# UNITED STATES PATENT AND TRADEMARK OFFICE

APPLICATION NO.	FILING DATE	FIRST NAMED INVENTOR	ATTORNEY DOCKET NO.	CONFIRMATION NO.
10/759,008	01/20/2004	Ryogo Kawai	118384	6829
25944	7590	04/15/2005	EXAMINER	
OLIFF & BERRIDGE, PLC P.O. BOX 19928 ALEXANDRIA, VA 22320			ADDISU, SARA	
			ART UNIT	PAPER NUMBER
			3722

<b>Office Action Summary</b>	<b>Application No.</b> 10/759,008	<b>Applicant(s)</b> KAWAI ET AL.	
	<b>Examiner</b> Sara Addisu	<b>Art Unit</b> 3722

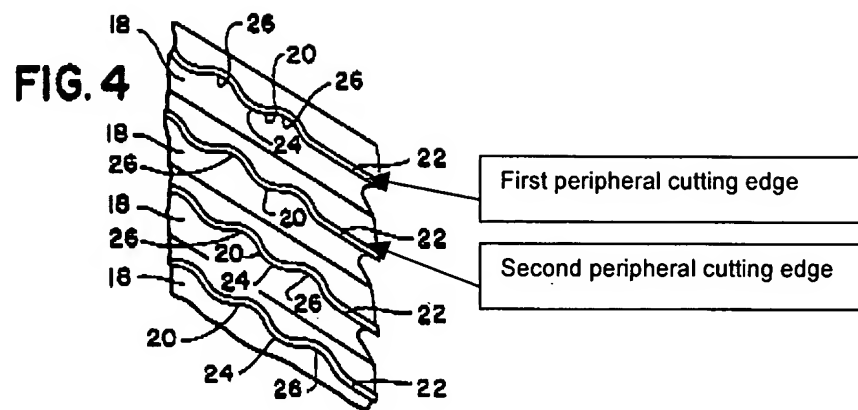
Deller teaches a rotary cutting tool having a cylindrical body, plurality of flutes (18) and peripheral cutting edges (i.e. first and second cutting edges) (20) (see diagram below). Deller also teaches continuous cutting edges (20) with generally sinusoidal shape having radial rake angle that varies between positive and negative along the edge. ('308, Col. 2, lines 53-58 & Col. 3, lines 21-26). Furthermore, Deller teaches the positive rake portion (valley) (i.e. first radial rake angle) of the first peripheral cutting edge being larger than the negative rake portion (peak) (i.e. second radial rake angle) of the second peripheral cutting edge ('308, Col. 3, lines 29-32).
